ADDENDUM NO.: 01
PROJECT NAME: Lincoln Park High School Renovation Project
PROJECT NO.: 05085
CONTRACT NO.: C1582
DATE OF ISSUE: April 27, 2017

NOTICE OF CHANGES, MODIFICATIONS, OR CLARIFICATIONS TO CONTRACT DOCUMENTS

SHEET #	1 OF 1	REVISIONS	DWG. NO.
DRAWN DATE	3/27/2017	1	ACM-3
DRAWN BY	J.DURAN	2	
APPR.	J.SHAH	3

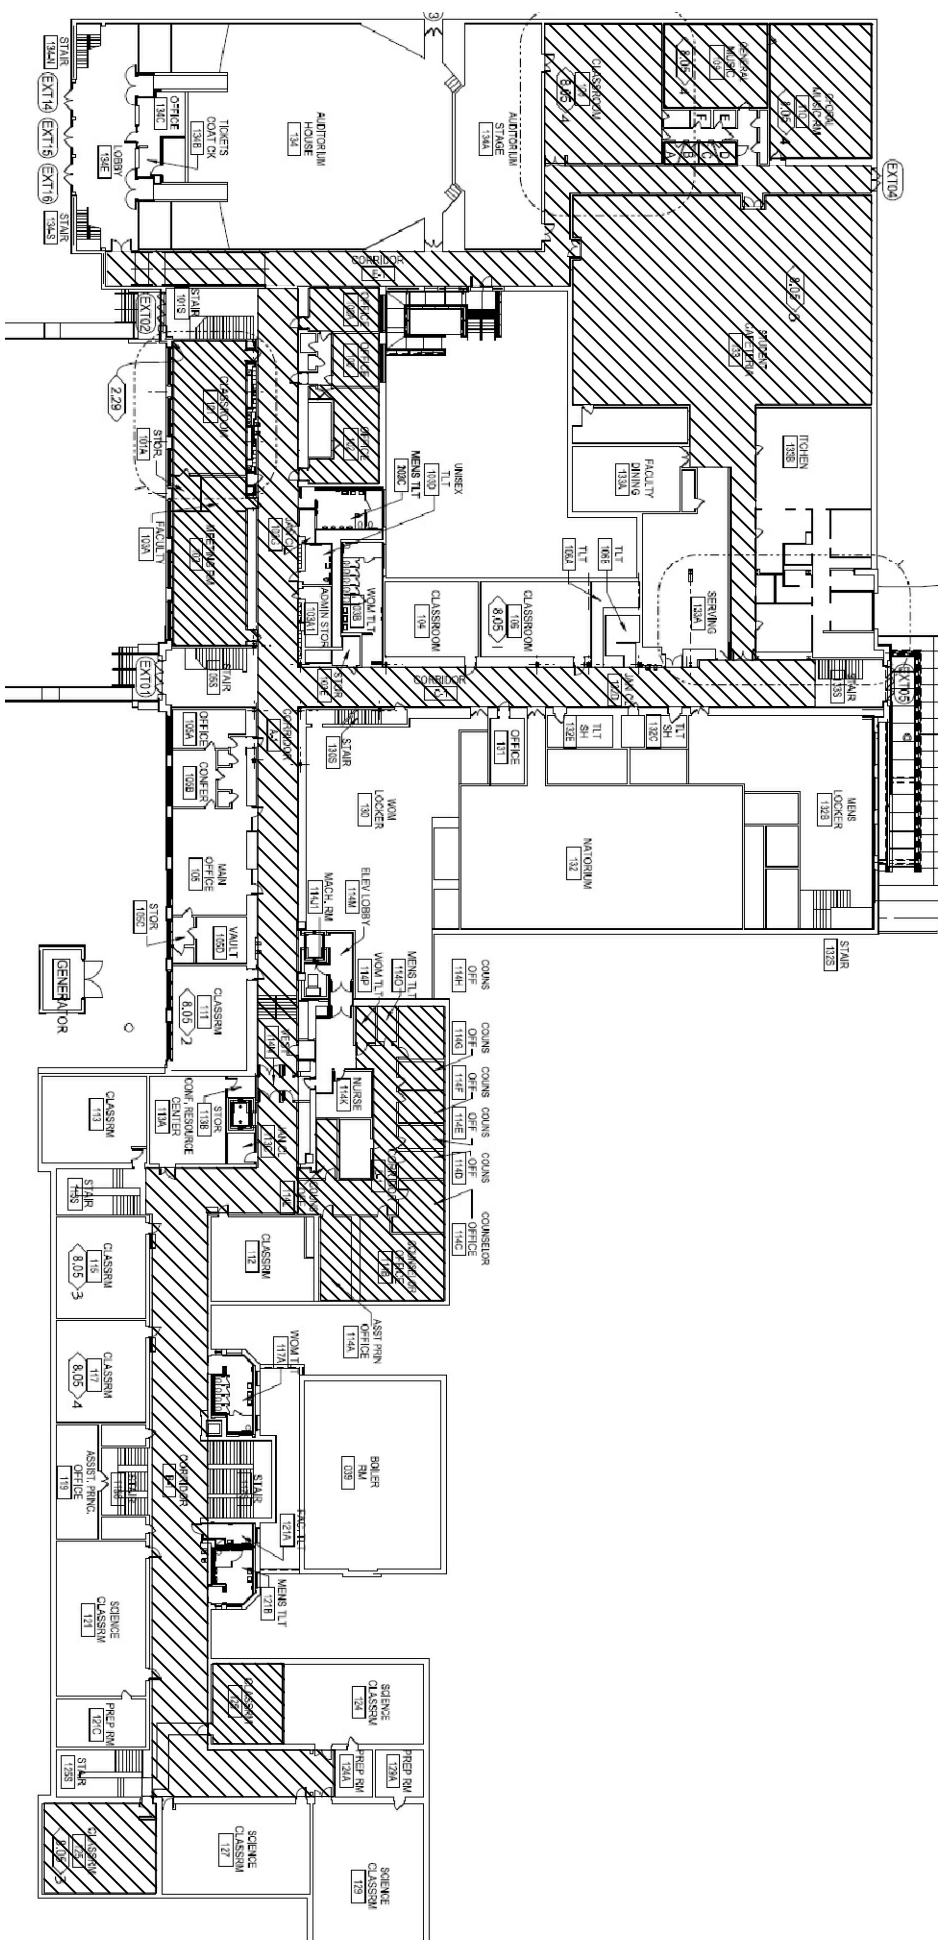
Question: Regarding Room 108, is there more than (1) layer of tile? Room is not shown hatched on ACM-2.

Response: [Yes. There is more than 1 layer of Vinyl Floor Tile \(VFT\) in Room 108. Although Room 108 was not hatched in the ACM-2 drawing, the scope of work to remove all layers of ACM is identified on the revised Environmental Scope Sheet #16 included in this Addendum.](#)

**ADD 1
A01**

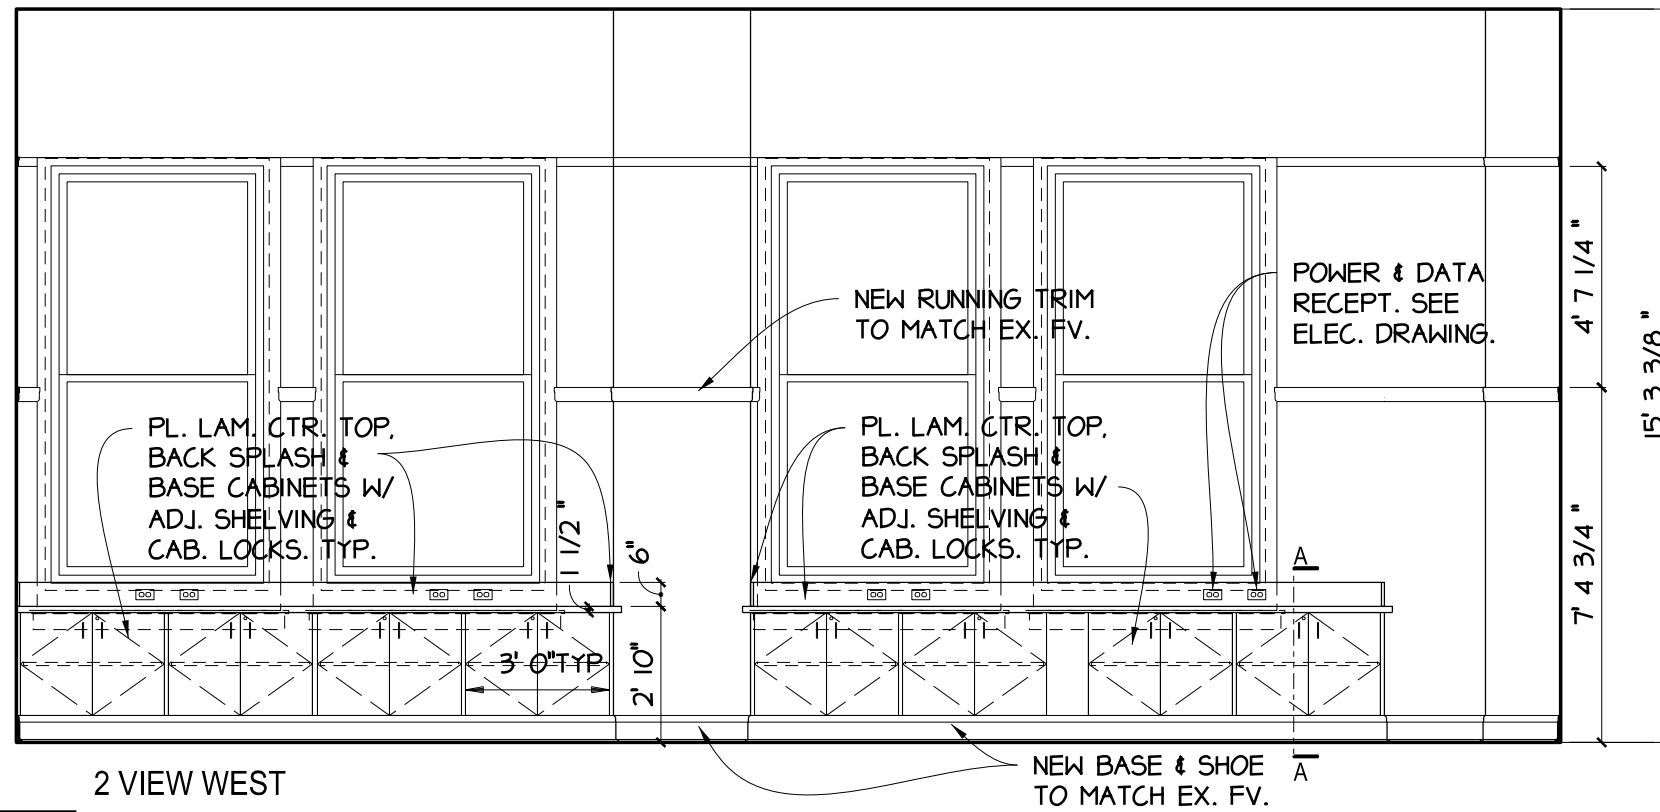
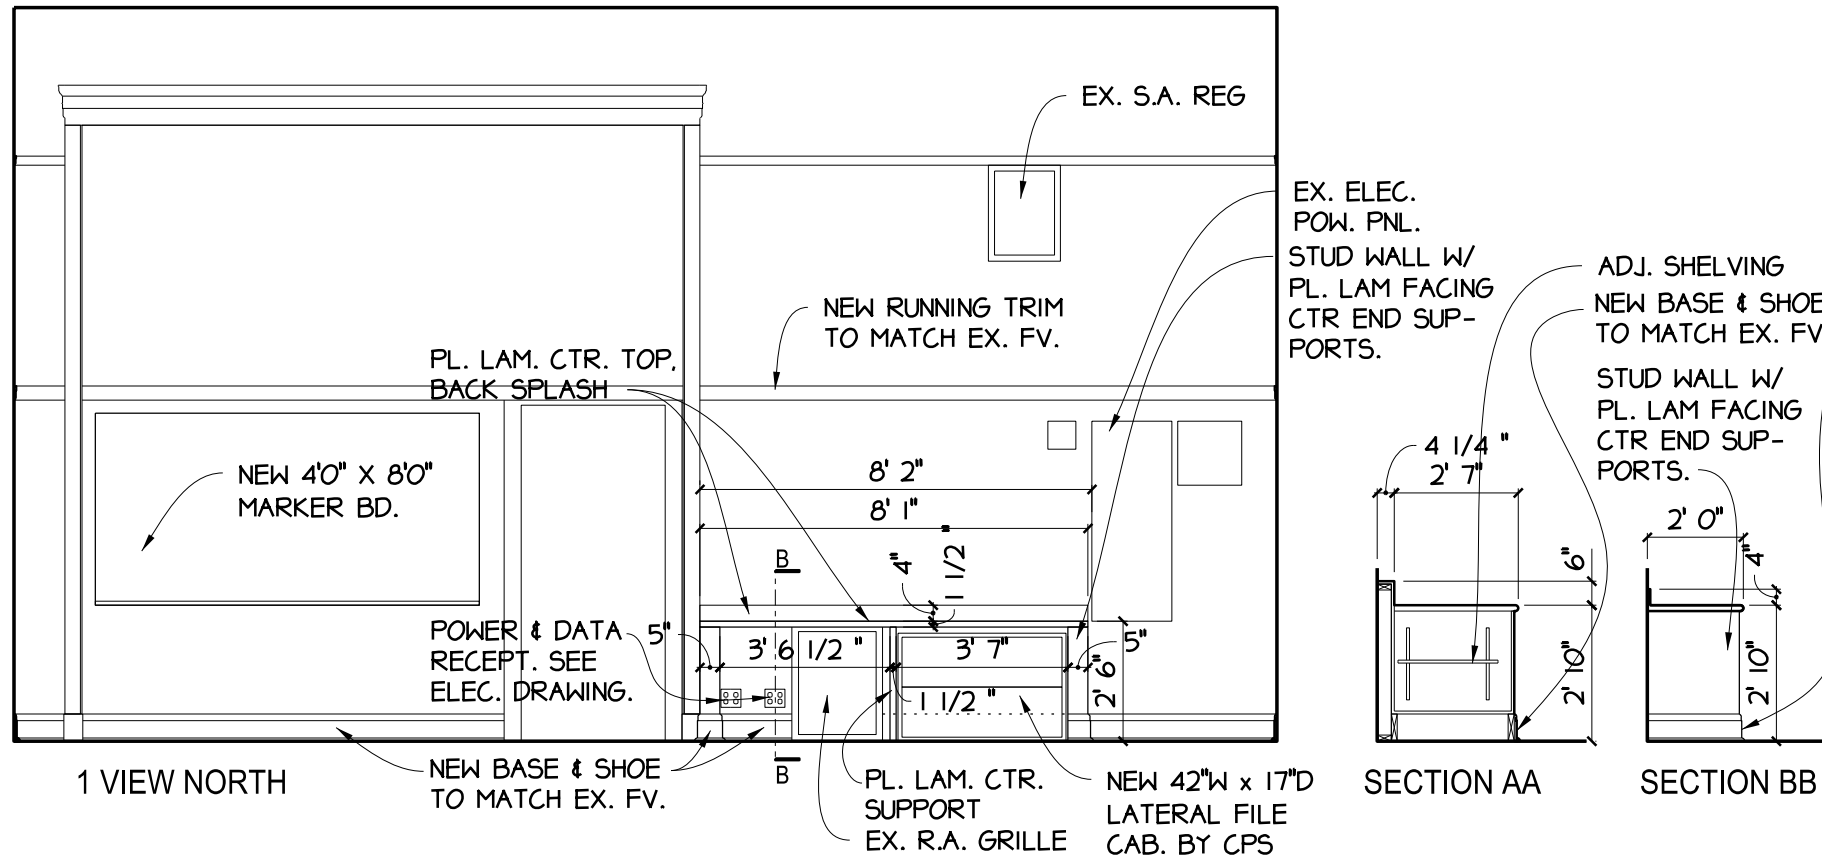
- Change No. 1** On Sheet A2.02: **ADD:** New storage cabinets; countertops; electrical power & data; door #219-1 in Computer Classroom 221, as per attached drawings: ADD 1 A01, ADD 1 A02, ADD 1 E01, ADD 1 ED01.

REVISED 4/A3.07 DETAIL

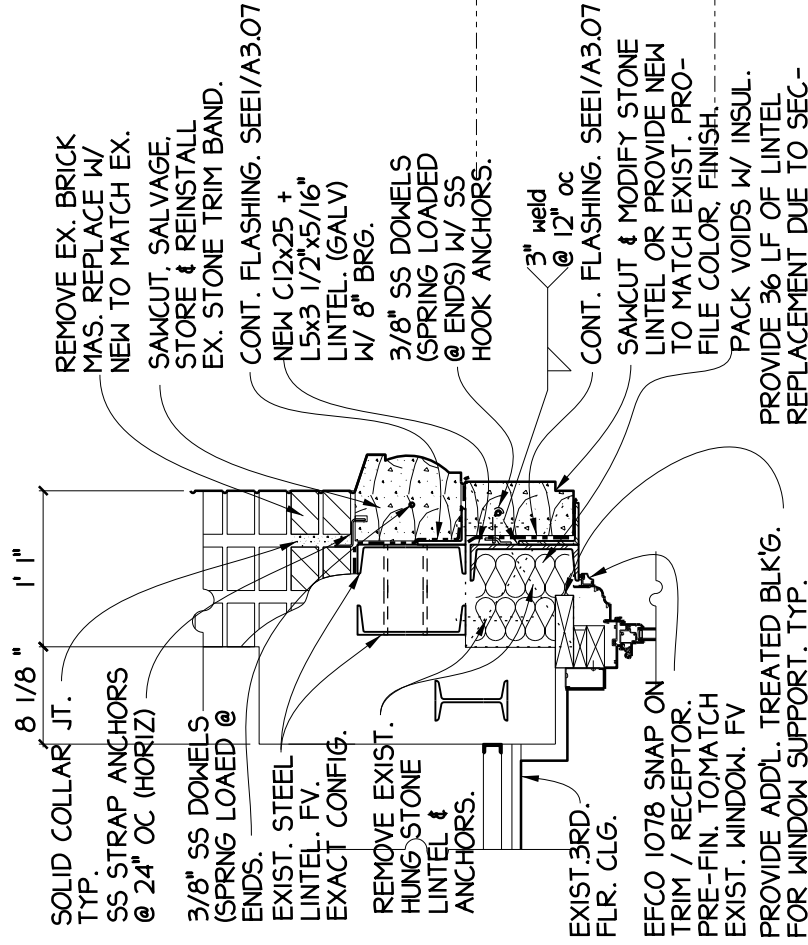
- Change No. 2** On Sheet A3.07, **DELETE:** Detail 4/A3.07. **ADD:** Attached revised detail drawing ADD 1 A03.
- Change No. 3** Sheet A1.05, Serving 165B, **ADD:** new in-line exhaust fan above Serving Area 165B ceiling with exhaust duct, through wall louver, new wall opening and lintel; ACT soffit and soffit fascia as per attached drawings: ADD 1 A04, MA2.02, MA5.00, MA5.01, E2.04.

Sheet **M1.01**

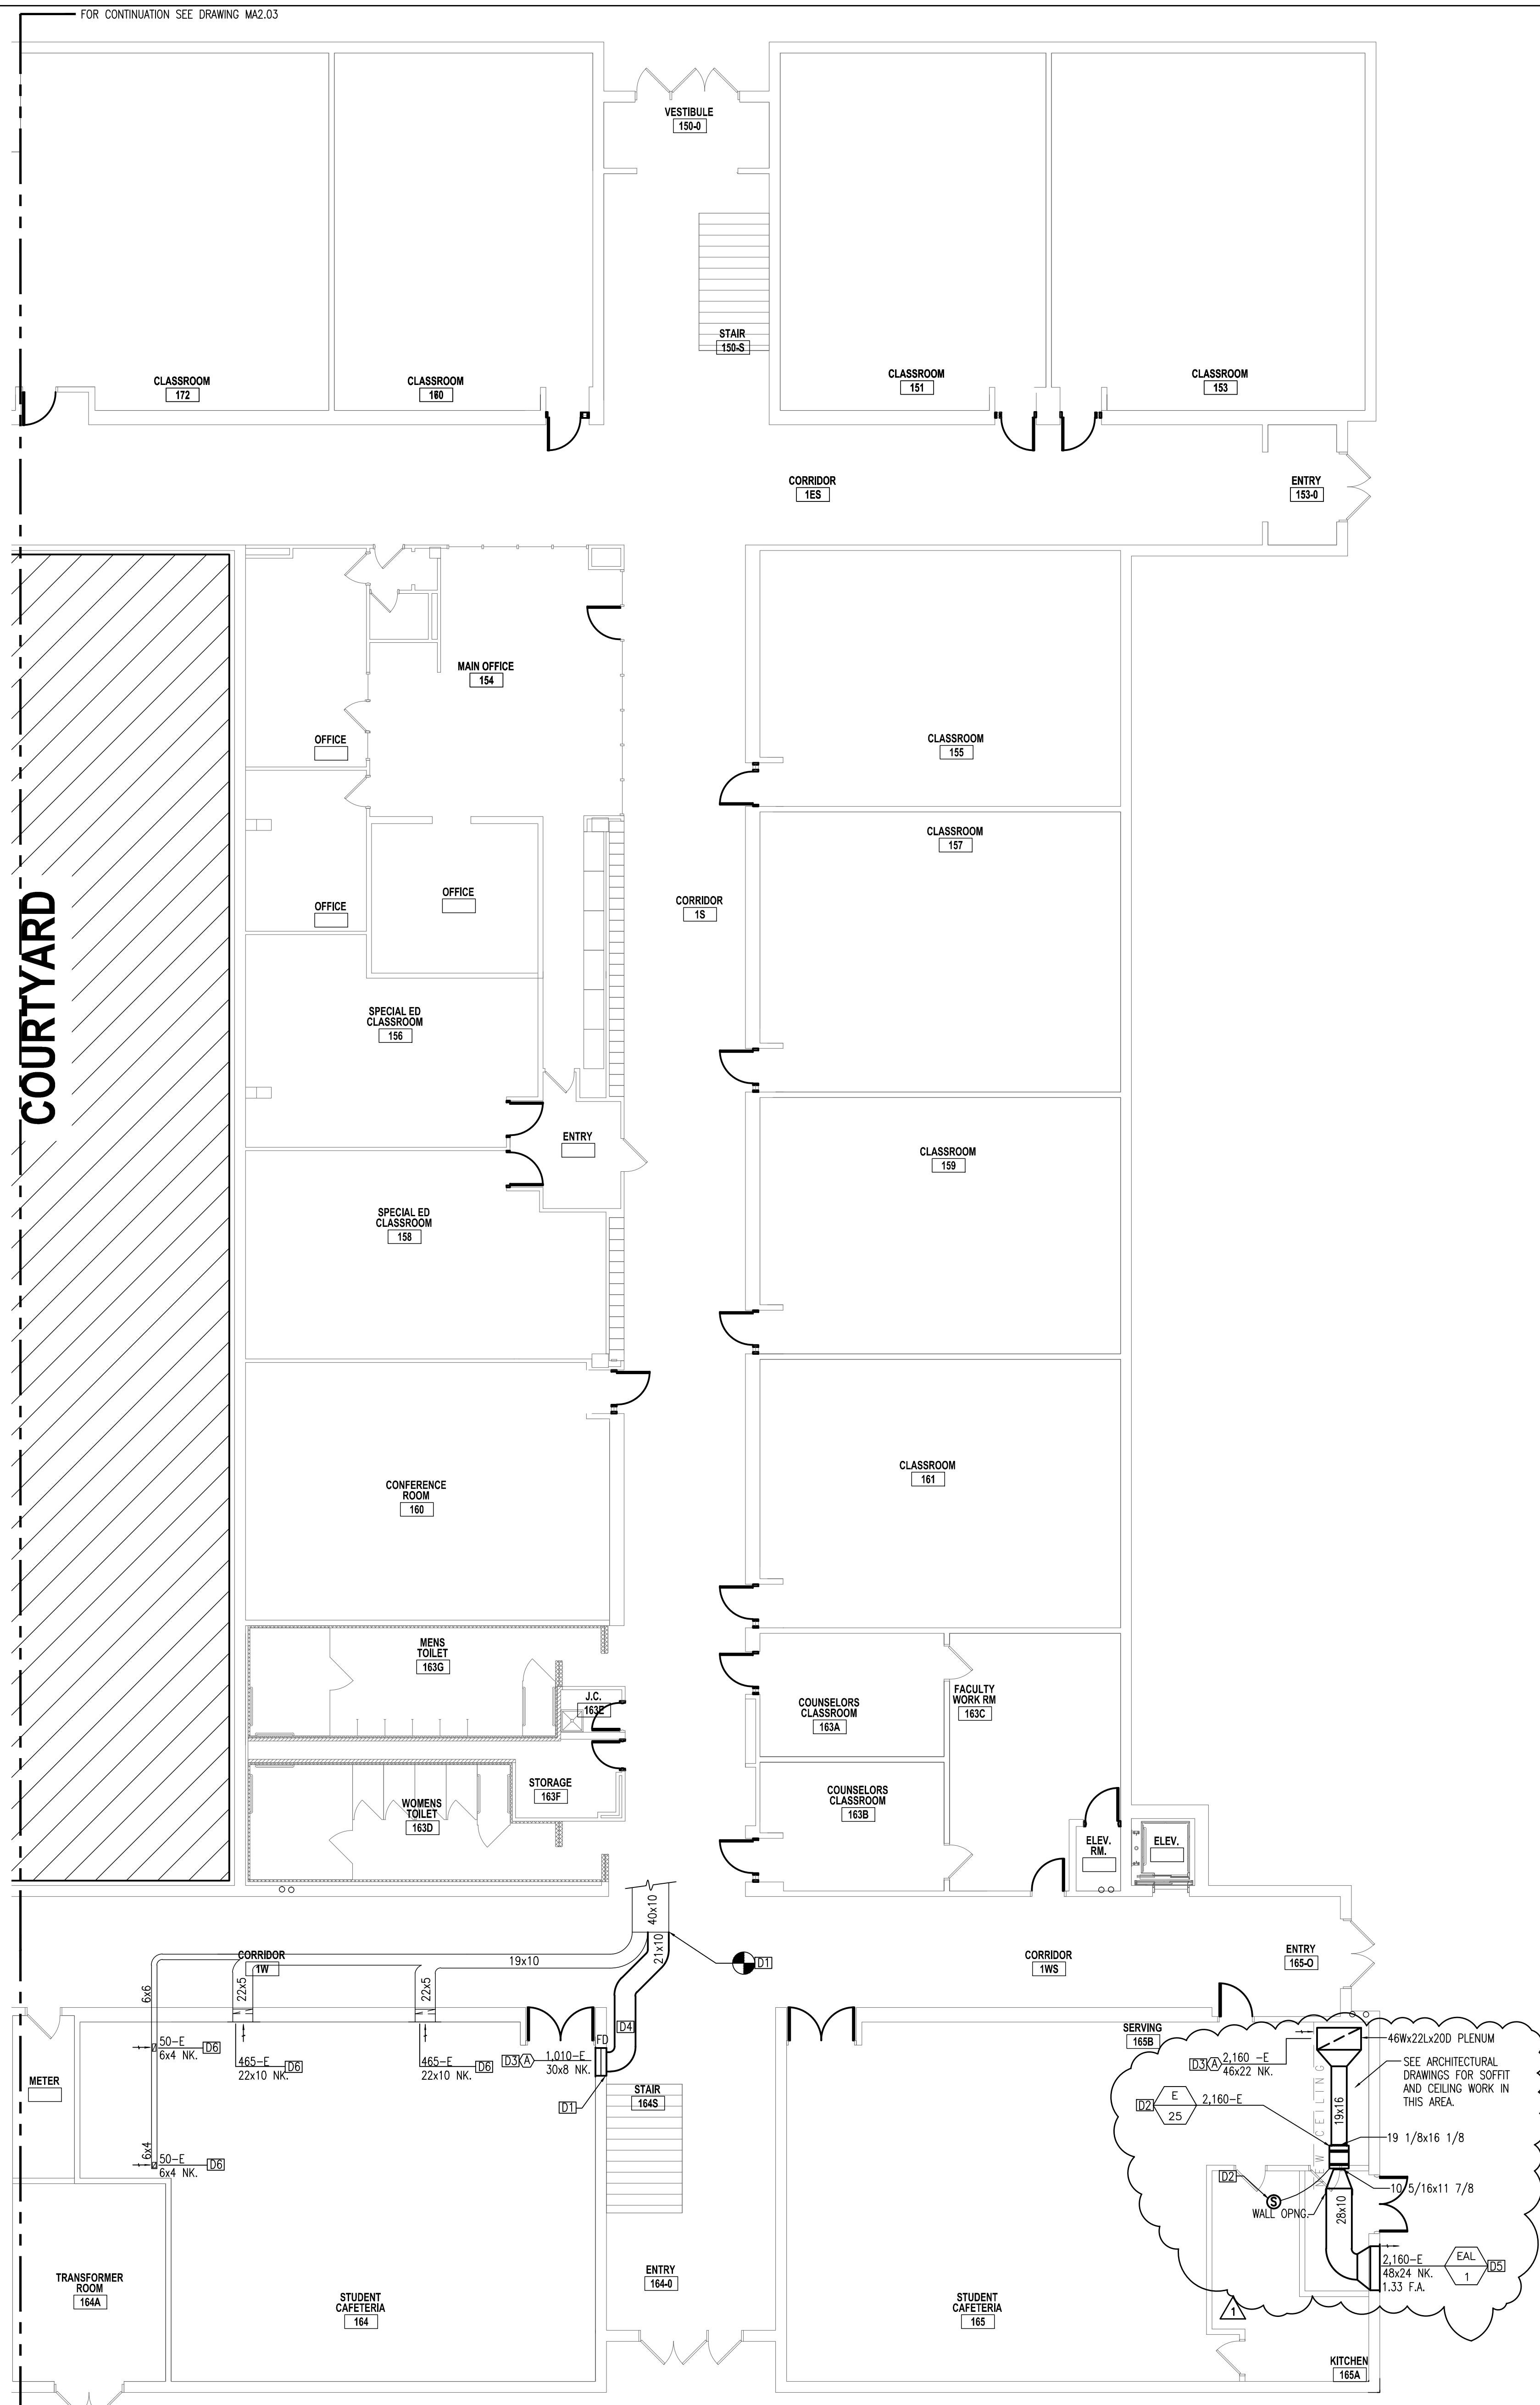
- Change No. 11 Sheet M1.01 ADD: Locations for patching of air tunnel walls.
- Change No. 12 Sheet M2.03 REVISE: Control damper tag at AHU-1.
- Change No. 13 Sheet M6.00
